Outdoor Solar-Powered Lighting Installation and Acoustic Mosquito Repellent for Unpowered Outdoor Structures

ECE CAPSTONE PROJECT – PROPOSED IMPLEMENTATION

October 7, 2020

Figure 1. Product concept diagram showing intended product installation method

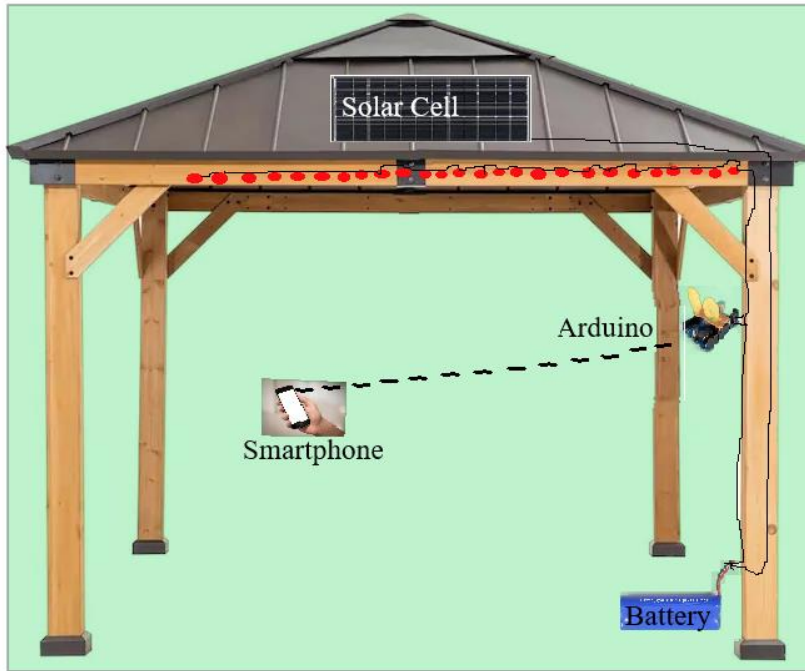
* Good job on your improvements to Figure 1, Matt.

* Page layout. When a figure is too large to fit at the bottom of the current page, it's okay to position that figure at the top of the next page, as you've done. What you don't want to do is leave a big, unfilled gap of whitespace at the bottom of a page, as was done here. Instead, move the heading "Functional Block Diagrams" and the paragraph that follows it from page 3 into this blank space on page 2. Next, reposition Figure 2 so it appears below Figure 1 on page 3, resizing Figure 1 or Figure 2 or both, as needed, to ensure both figures and their captions fit on one page.

Figure 2. Functional Block Diagram for the proposed project.

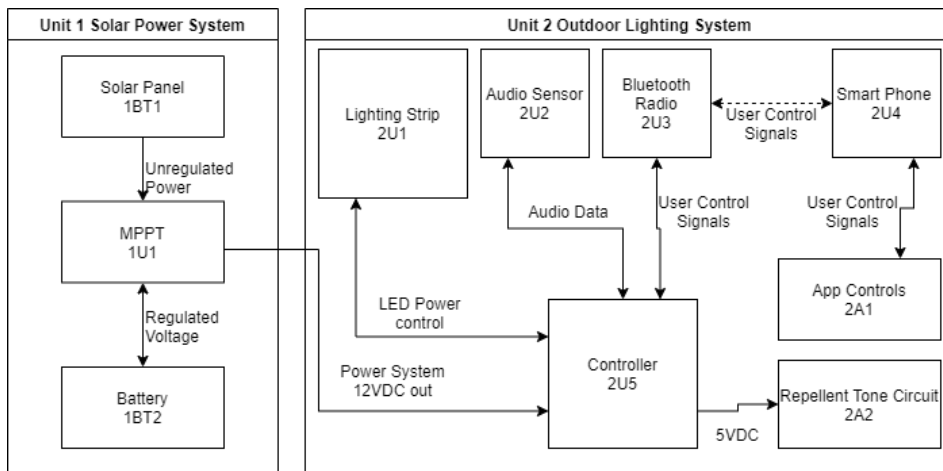
Commented [JDF6]: In this description, don't use/add identifiers that do not appear in Figure 2.

* Good job on your revisions to figure 2.

* The SMARTPHONE element should be a stand-alone element; it is not an element that you are creating and building into UNIT 2. If you purchase this product at Best Buy or Home Depot, you would not find a SMARTPHONE in the packing box along with UNIT 1 and UNIT 2. The SMARTPHONE is a stand-alone element that the customer provides, and therefore the SMARTPHONE should be displayed outside UNIT 1 and UNIT 2.

* Two different signal paths are labeled **USER CONTROL SIGNALS**. When you assign multiple signal paths the exact same label 'X', you are indicating that those multiple signal paths are in fact the same signal path (they are one signal path); they are not separate / distinct signal paths.

* The reference designation **A*** describes a "separable assembly" that is realized as a physical assembly constructed from basic parts like resistors, capacitors, integrated circuits, solder, circuit boards, etc. In Fig. 2, is **APP CONTROLS 2A1** realized as a physical assembly that someone in your group will construct from basic parts? If not, it should not be shown on this figure.

* On the signal path labeled **POWER SYSTEM 12VDC OUT**, remove the word "OUT" as it is redundant; it is self-evident from the directed line segment (a line with an arrowhead at one end) that this signal is coming "out" of the MPPT.

* Insert a [non-breaking space](#) (and preferably a narrow non-breaking space U+202F) between a number and its units: 12 VDC (12<NBSP>VDC) and not '12VDC'. Likewise, 5 VDC (5<NBSP>VDC), not '5VDC'.

Commented [JDF8]: *functional block diagram* is an improper noun, and therefore is not capitalized. Of course, in this case the word *functional* appears as the first word in a sentence, and therefore that word should be capitalized.

Also, do not use Title Case Capitalization for caption text; write caption text as an ordinary sentence.

Commented [JDF14]: Remove from this table anything that is not a physical assembly. For example, is 2A1 as a physical assembly that Nicholas will design and construct with basic electronic components? If not, then 2A1 doesn't belong in this table, and it should be removed from figure 2.
